CHANGE ORDER REQUEST

JOB #:101520
MOD #: 0007 -01
DATED: 10/26/10

RE: Neenah Menasha Fire
Rescue Station 36
1108 Province Terrace
Menasha WI 54952

Report of Subgrade Preparation Observations

Subgrade Location: Fire Truck Exit (see map)

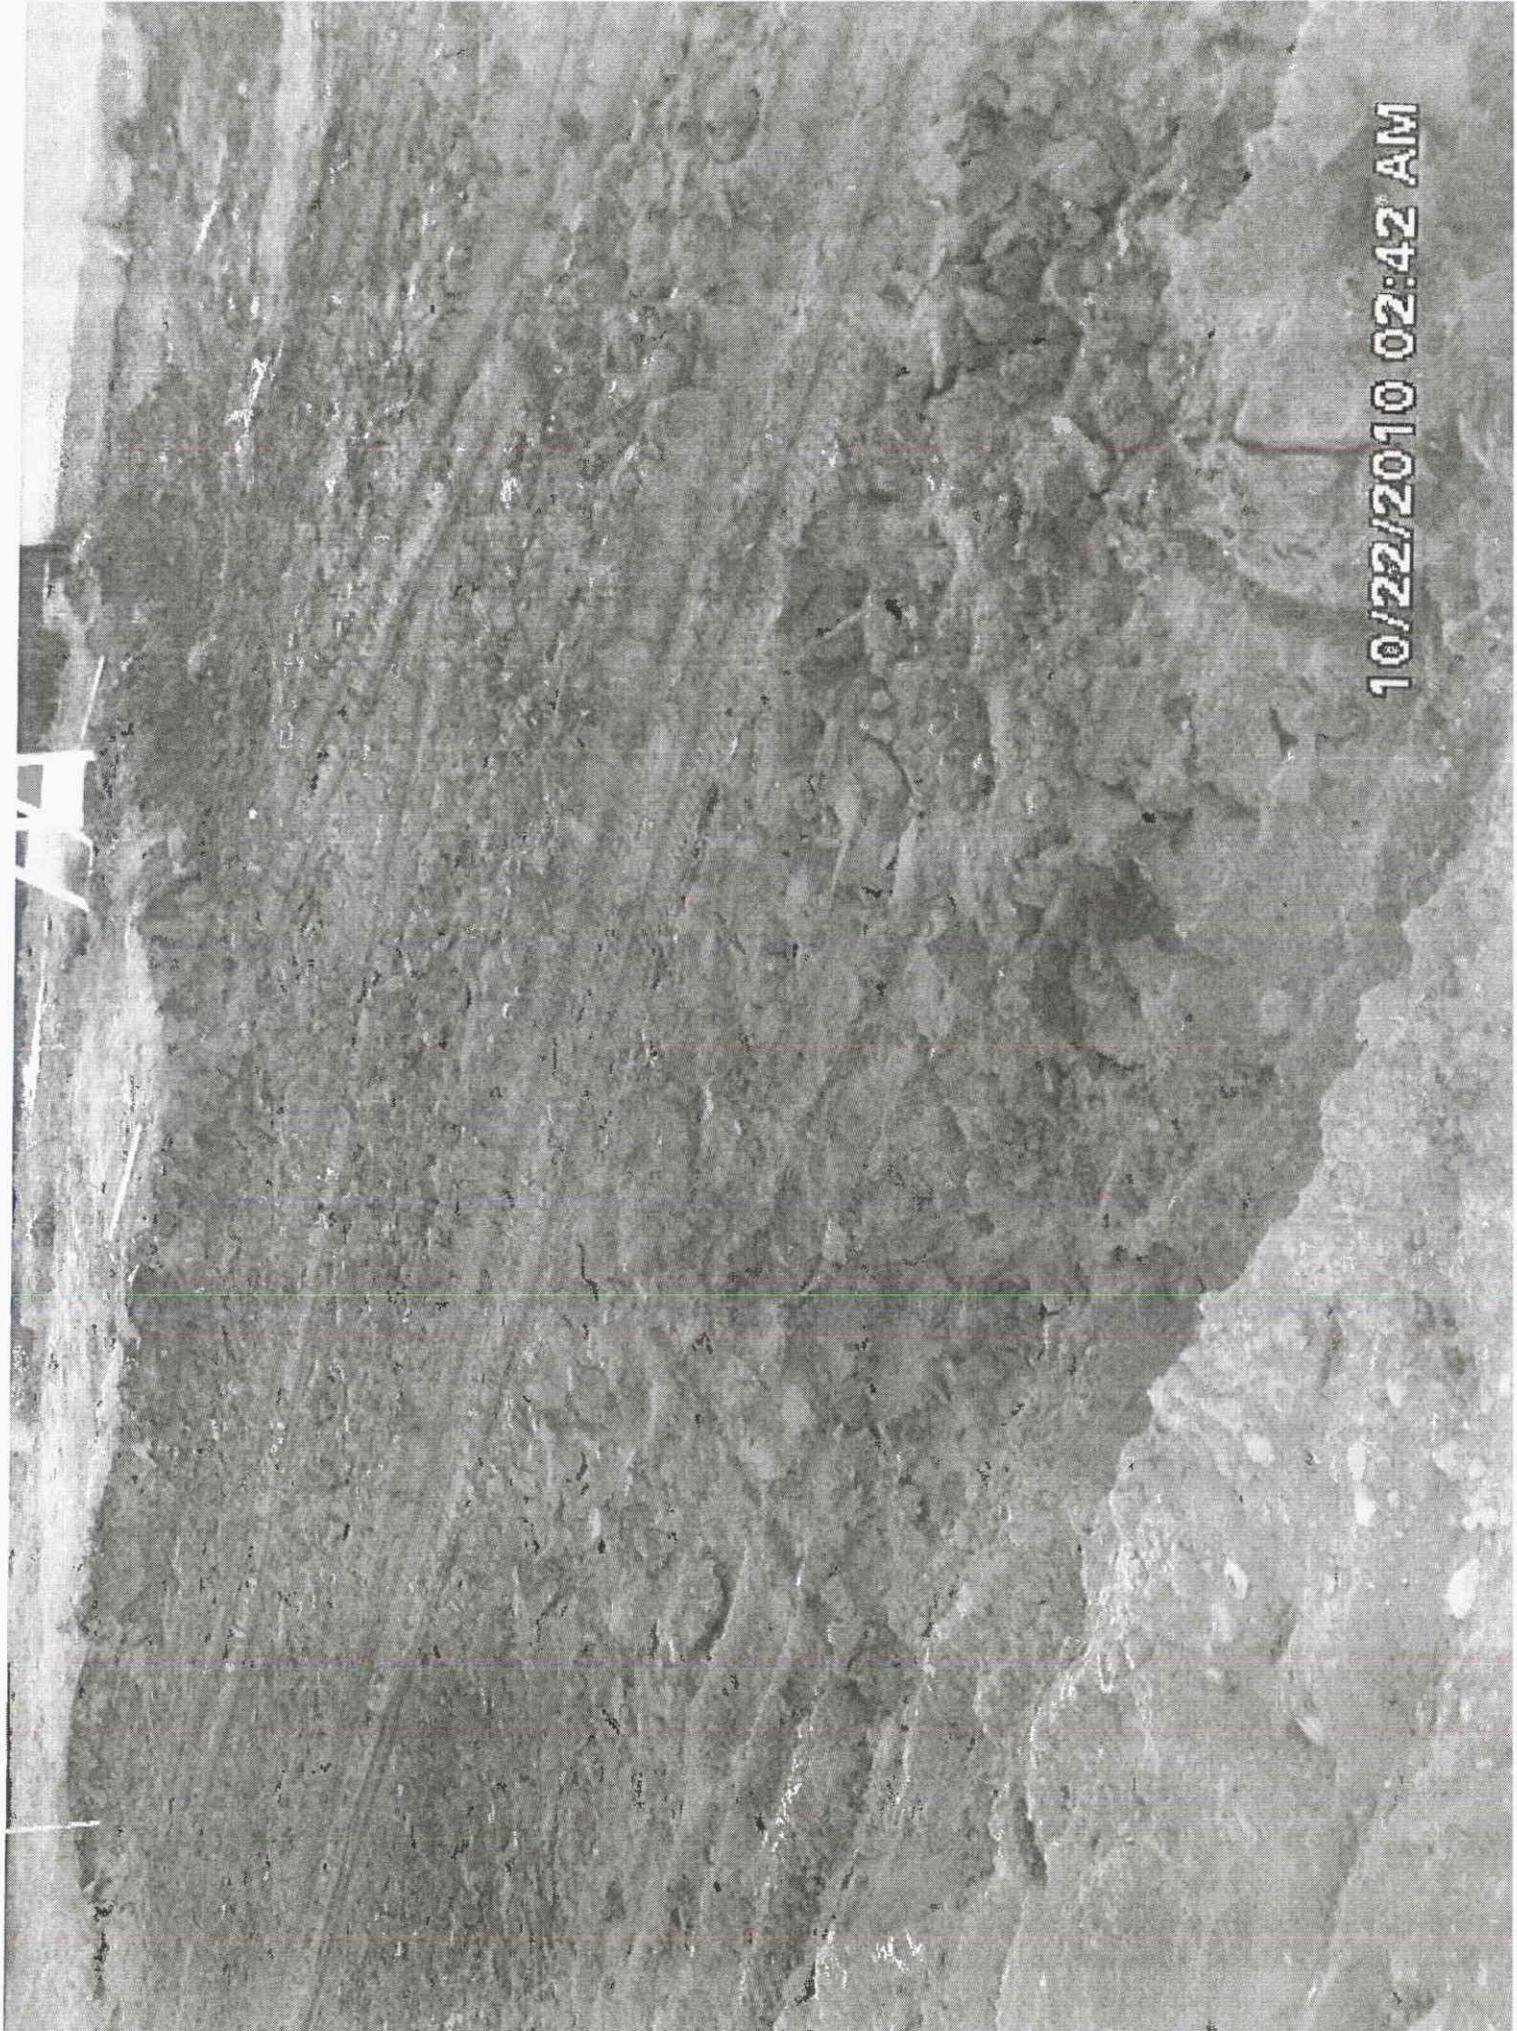
Subsequent to topsoil stripping, the grade was observed to be 10 to 26 inches below the design elevation. The subgrade was proofrolled and rutting was observed. Therefore MES recommended placing fabric and compacted 3 inch crushed gravel.

Remove unsuitable soils on north side of Apparatus Bay.
Provide engineered fill. Provide segregation fabric.
